24 June 2016

**Response to Public Exhibition of the State Significant Infrastructure Application for the Sydney Metro City & Southwest - Chatswood to Sydenham
8 Chifley, Sydney**

FIGURE 6 – MARTIN PLACE CONSTRUCTION SITE AND 8 CHIFLEY (SOURCE: TRANSPORT FOR NSW, 2016)

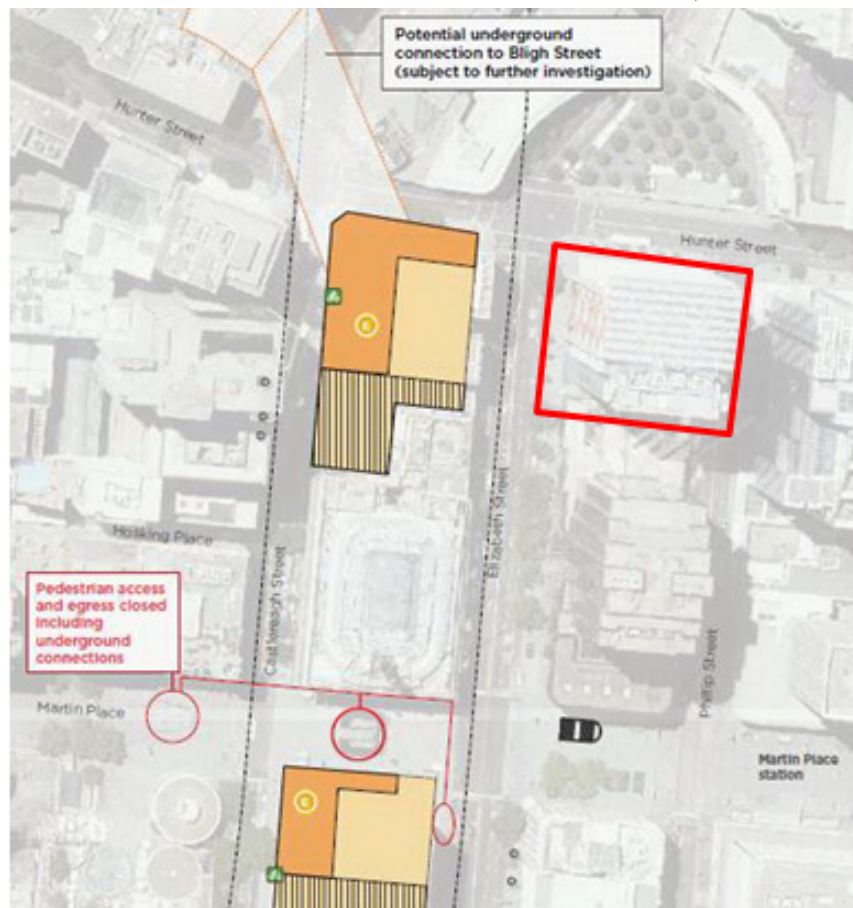
The indicative construction site layout (provided as **Figure 6** within this submission) shows that the proposed left-out exit driveway is to be located immediately opposite the access driveway to the basement level of 8 Chifley. Concern is raised that the heavy and light construction vehicles exiting this driveway could have an adverse effect on the accessibility and operational safety of the 8 Chifley driveway which provides access to 32 car parking spaces, four courier bays, a service vehicle bay, 129 tenant bicycle spaces and 28 visitor bicycle spaces.

The proposed Road Safety Audit (Reference T2) should include further assessment of the proposed siting and design of the construction vehicle exit driveway from the Martin Place Station construction site to avoid operational and safety impacts on the existing access driveway to 8 Chifley.

- A detailed layout plan for the construction site that incorporates a revised location for the proposed left-out exit driveway.
- A detailed list of procedures and mitigation/management measures to maintain adequate safety for pedestrians, cyclists and vehicle drivers.

- The proposed left-out exit driveway from the Martin Place Station construction site to Philip Street needs to be relocated to avoid causing conflicts with the access driveway to 8 Chifley.
